SERVICE BULLETIN

SUBJECT: ELECTRICAL POWER – Static Inverter AI² Part Number 1-002-0102-2173 – Modification.

TRANSMITTAL: Service Bulletin 1-002-0102-2173-24-41 Initial Release (Revision 0).

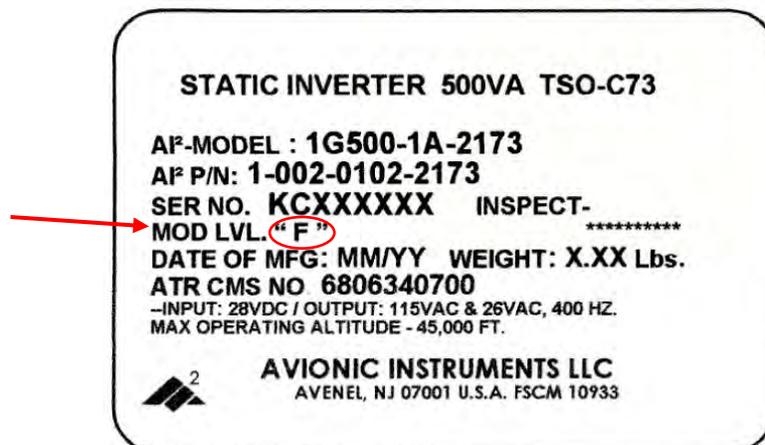
Upon completion of the modification, the label on the cover will be changed to indicate MOD Level "F". See figure below:

Figure 3

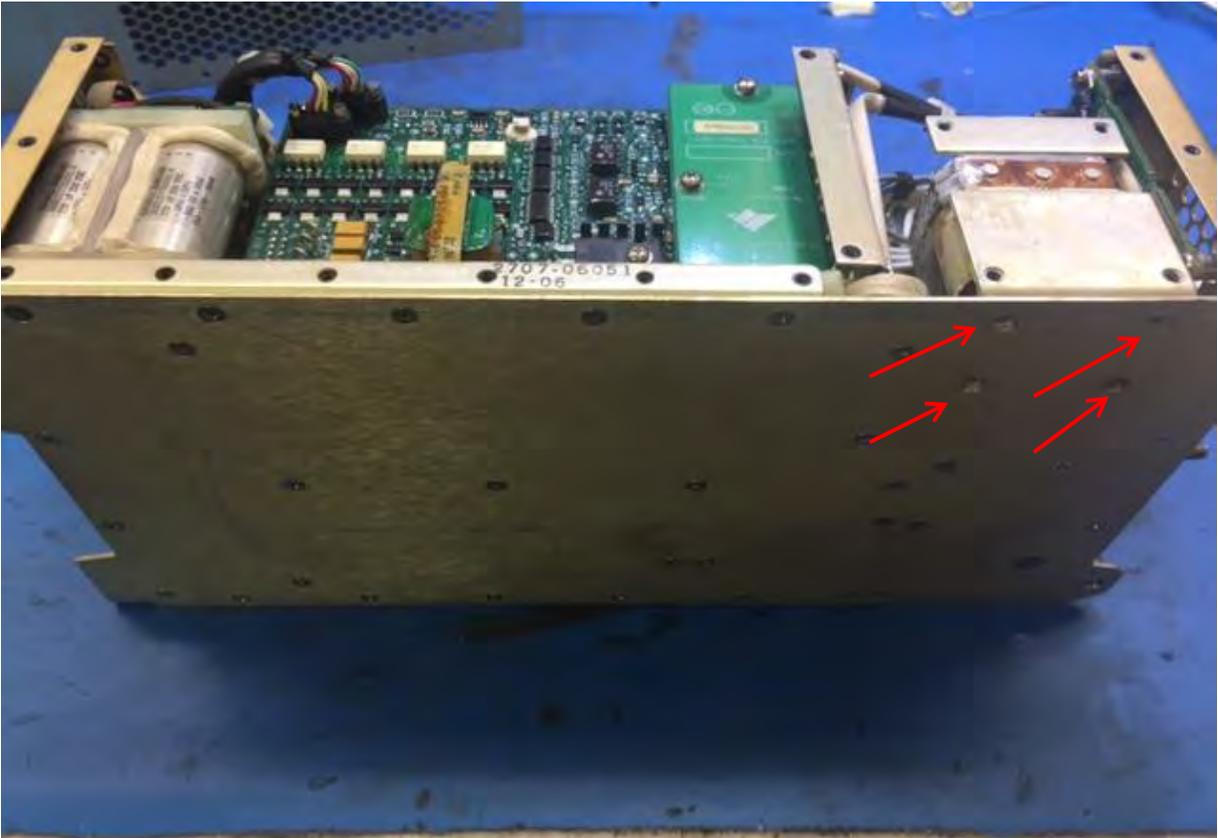
1. Remove 48 screws (51957-12) from the cover of the unit. (Figure 1).
2. Remove the cover from the unit. (Figure 2).
3. Disconnect the transformer from the base plate by removing (4) screws (24693-C2) from the base of the unit. (Figure 3, Figure 4).

Figure 5

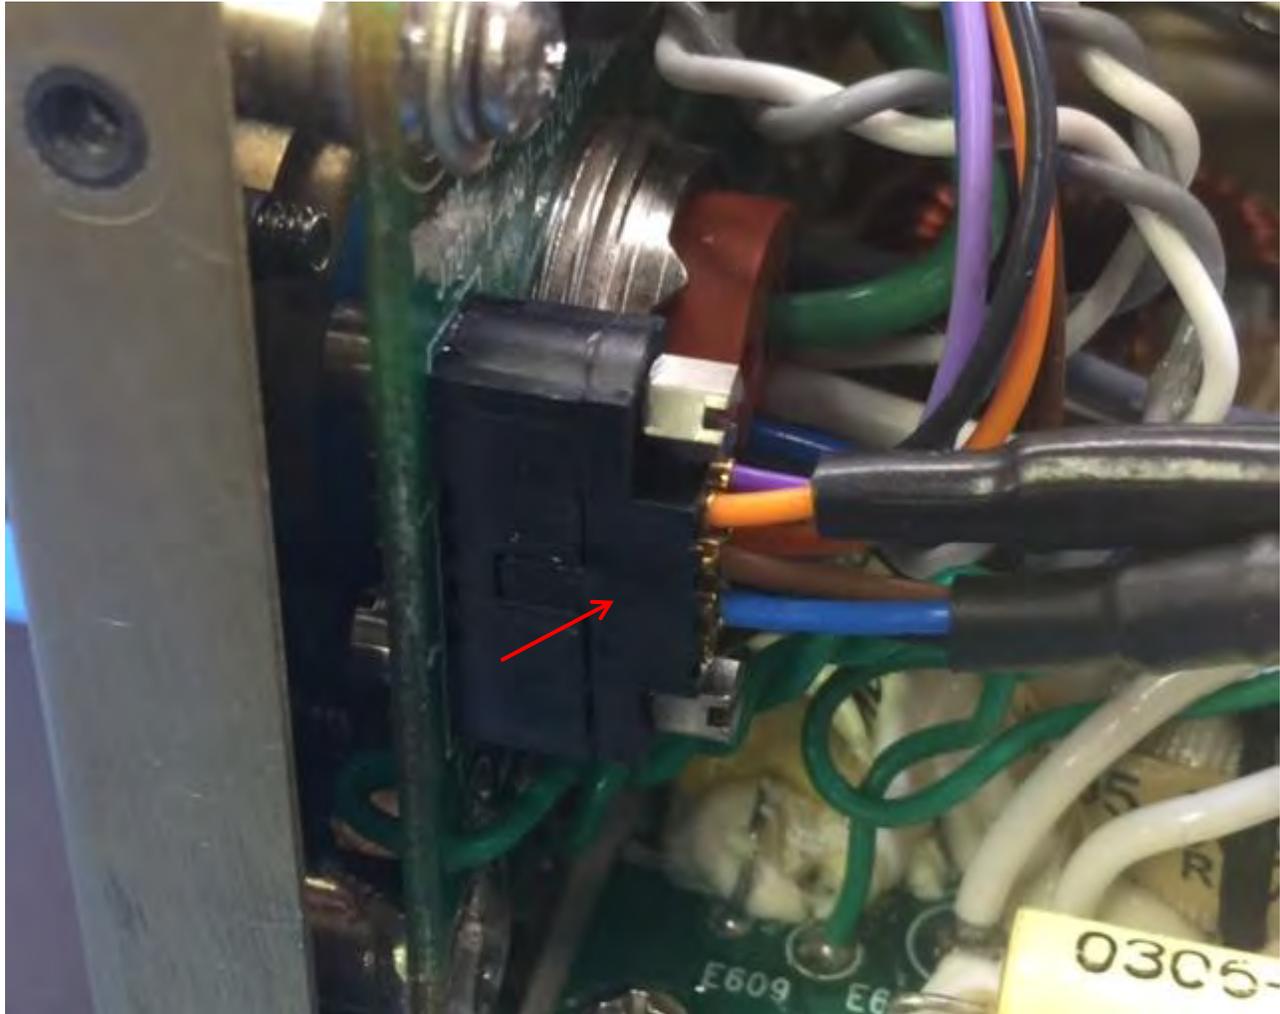
4. Disconnect the connector from the AC connector/ alarm assembly. (Figure 5, Figure 6).
5. Disconnect the wires/cables by de-soldering at locations E602, E603, E605, E608, E609 and E610 on the EMI Output board assembly (Soldering Iron tip JBC C245-741). (Figure 7, Figure 8, Figure 9, Figure 10, Figure 11, Figure 12).

Figure 13

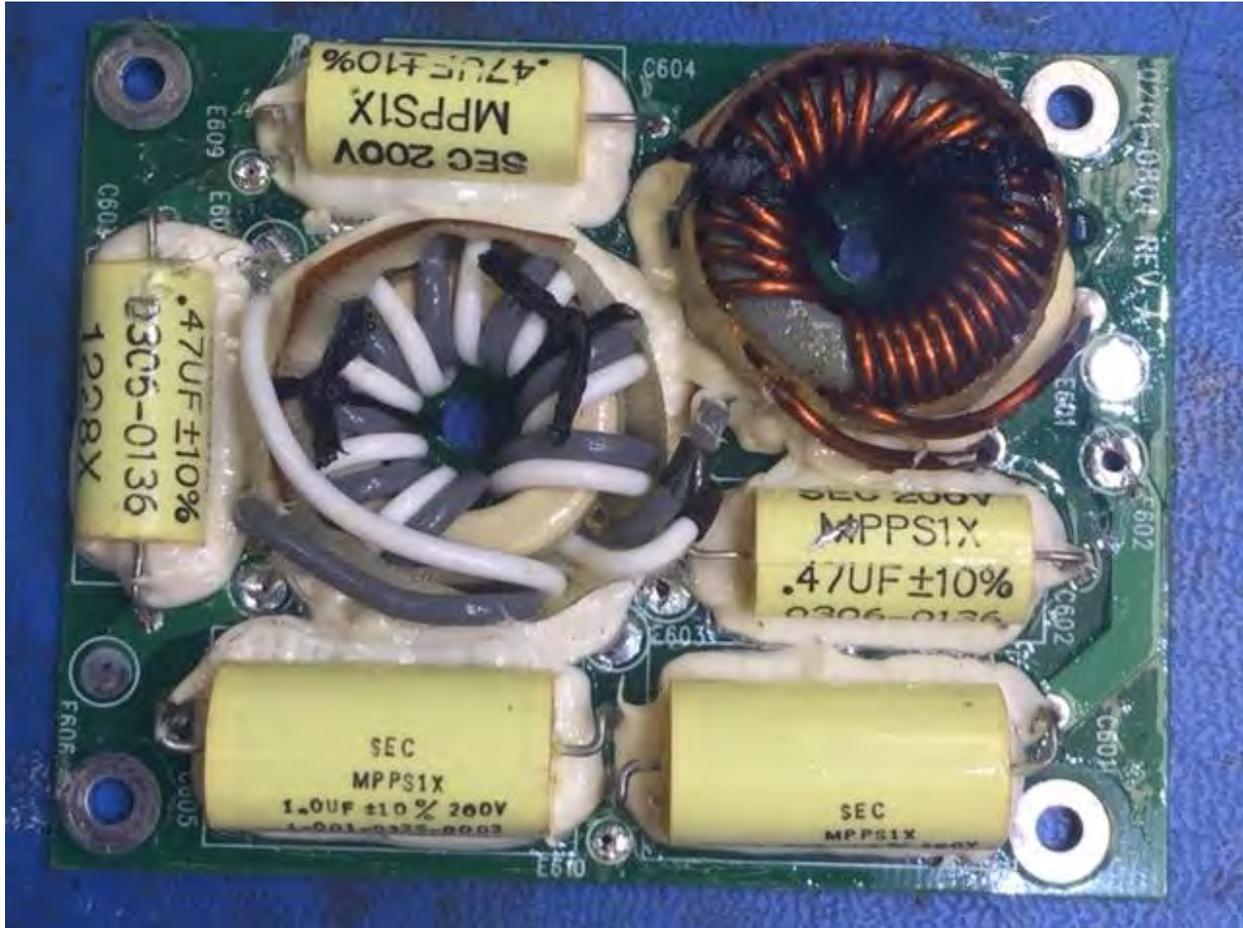
6. Remove EMI Output Assembly from EMI shield by removing (4) screws and washers. (Figure 13).
7. Remove capacitors by cutting leads with a cutter. (Figure 14).

Figure 15

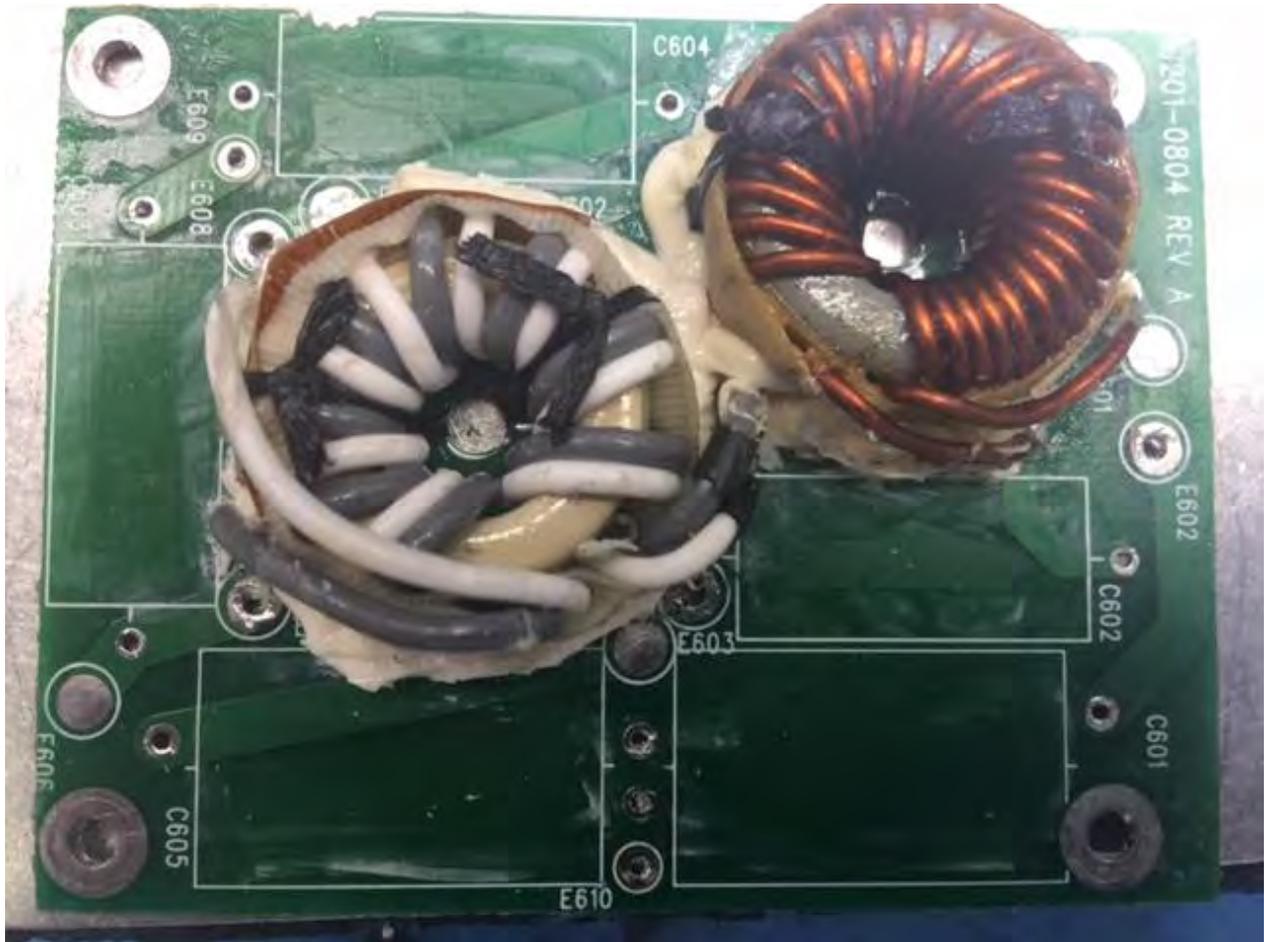
10. Manually clean the PCB holes with alcohol.
11. Apply thinner (1-001-2302-0019, T521-5L) over the old RTV and peel it off after 5 mins of dwell time. (Figure 15).

Figure 17

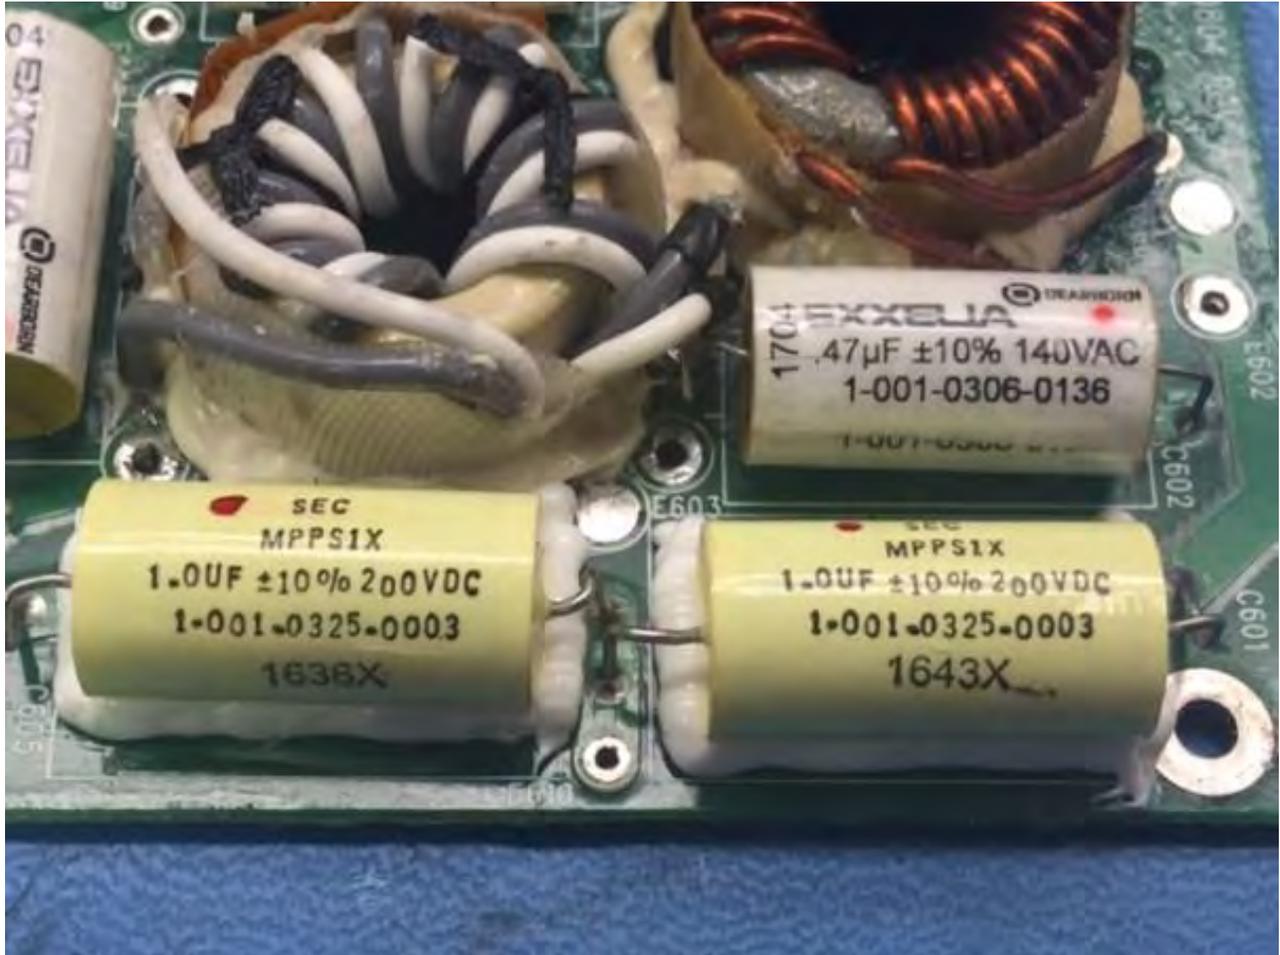
13. Apply RTV (MIL-A-46146) around the capacitors. (Figure 17, Figure 18).
14. Manually brush capacitors (top surface & soldered areas) with conformal coating (MIL-I-46058).
15. Assemble the repaired EMI output assembly (1-002-01008-0256) onto the EMI shield using (4) screws/washers.
16. Solder wires/cables at locations E602, E603, E605, E608, E609 & E610 on the EMI Output board assembly using solder wire (1-001-2301-0002, CLEANLINE 7000, 0.032" DIA, 63 SN 37 PB 2% FLUX) and soldering iron (tip JBC C245-906 or equivalent). (Figure 7, Figure 8, Figure 9, Figure 10, Figure 11, Figure 12).

Figure 19

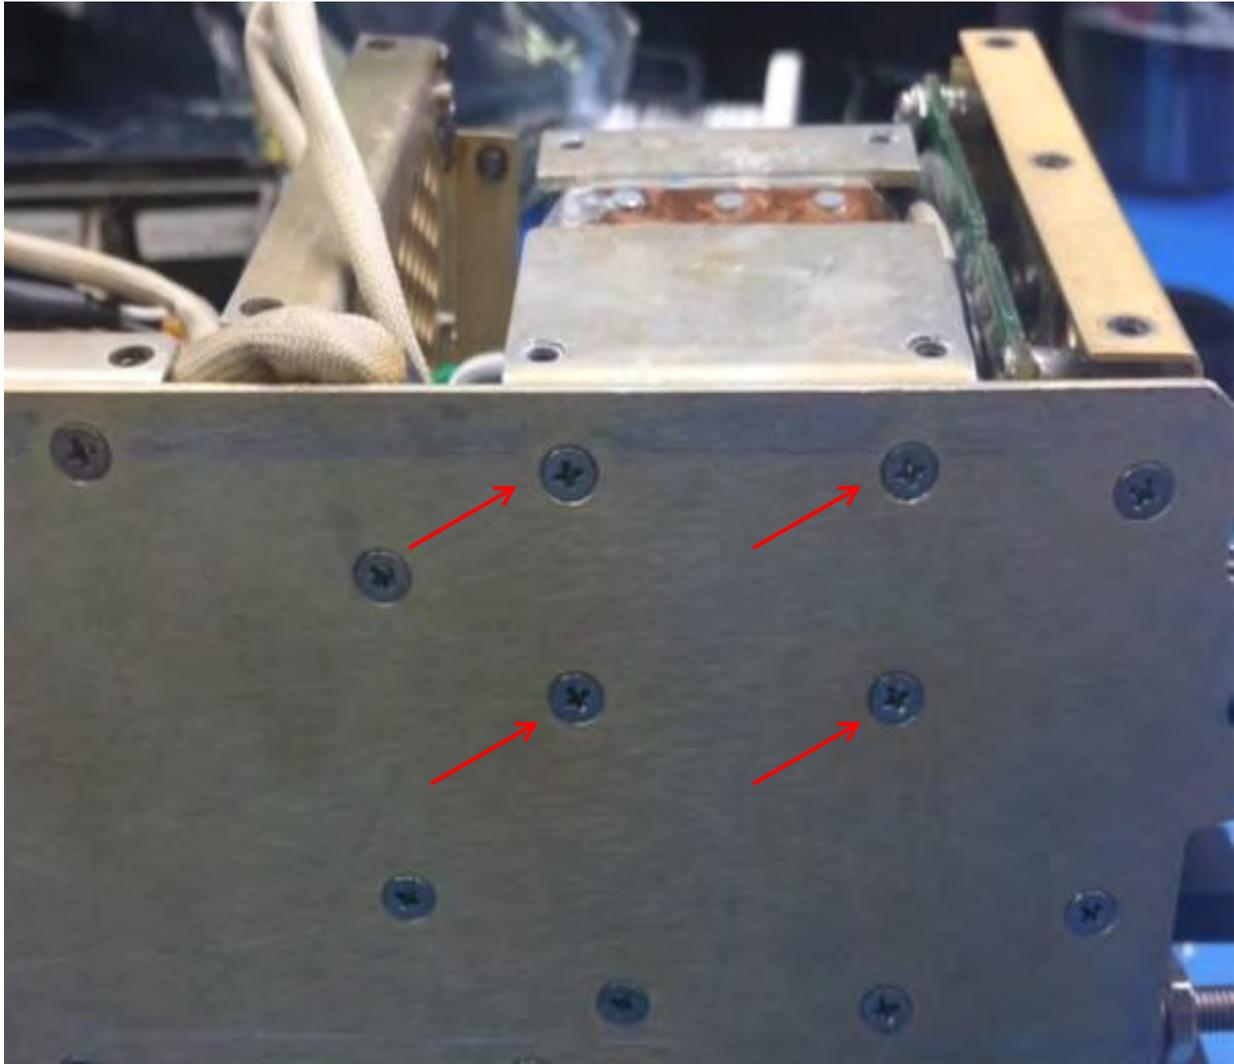
17. Apply conformal coating (MIL-I-46058) to the soldered areas.
18. Assemble transformer (1-005-0701-0470) to the base plate (1-002-0117-0097) using (4) screws (24693-C2). (Figure 19).
19. Connect the connector from the AC connector/alarm assembly (1-002-0108-0255). (Figure 20).
20. Secure the wires with grommet (1-001-0204-0029, Type 6/6). Secure the cables with cable tie (MS3367-5-9). (Figure 21).
21. Attach cover on to the unit using (48) screws (51957-12). (Figure 1).
